STAFF RECOMMENDATION
1610 16th Avenue South
August 21, 2019

Application: New Construction—Addition; Partial Demolition
District: South Music Row Neighborhood Conservation Zoning Overlay
Council District: 19
Base Zoning: OR20/Comm. PUD
Map and Parcel Number: 10408 035100
Applicant: Rodney Young, CDP Architecture
Project Lead: Melissa Baldock, melissa.baldock@nashville.gov

Description of Project: Application is to reconfigure the existing addition and attached garage and construct a new rear addition. The project involves the demolition of a former two-story rear porch and a part of the non-contributing garage.

Figure 11.

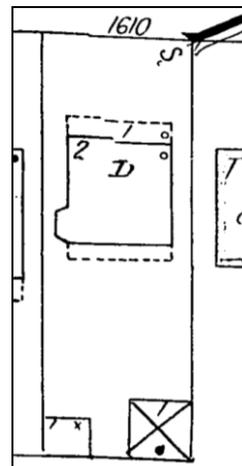
The project also involves the removal of a portion of the rear of the house that is likely original (Figures 7 – 11). At the rear of the brick house is a two-story frame section with a shed roof form separate from the main hipped roof. This frame portion was likely originally a two-story porch, possibly a sleeping porch, that later, was more fully enclosed. It appears in the 1914 Sanborn map as a porch (Figure 12). Although an original feature of the house, these older porches were often not constructed to last more than one hundred years and are often significantly altered. In this case, the shape of the porch may be the same as the original, but the area would have likely been much more open in nature to let in air. The structure is clad in vinyl siding and has lost its original openings. It is located at the rear of the house, not highly visible from the street. Staff finds that the porch's removal will not significantly alter the historic character of the historic house, particularly since the porch has a separate roof form that sits lower than

the historic house's roof form and since the addition is inset approximately one foot (1') from each of the house's back corners. Staff therefore finds that its removal meets the design guidelines.

Staff finds that the proposed partial demolition to meet Section III.B.2. of the design guidelines for appropriate demolition.
